## FORD WATER PUMP BWP1790 IMPORTANT INFORMATION

Issue Date: 24/09/10 Issue Number: COTB0015B

**APPLICABLE REFERENCES: BWP1790**

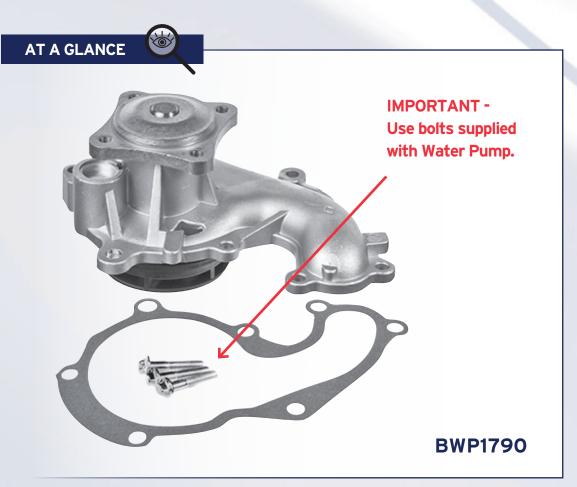
It is imperative to use the bolts that are supplied with this water pump due to changes to the thickness of the pump body.

Failure to use the supplied bolts in the correct orientation will cause serious damage to the engine block, which would be immediately apparent.

It is essential that care is taken when installing the pump, as the bolt protrusion can damage the engine block water jacket if they are not located in the correct position.
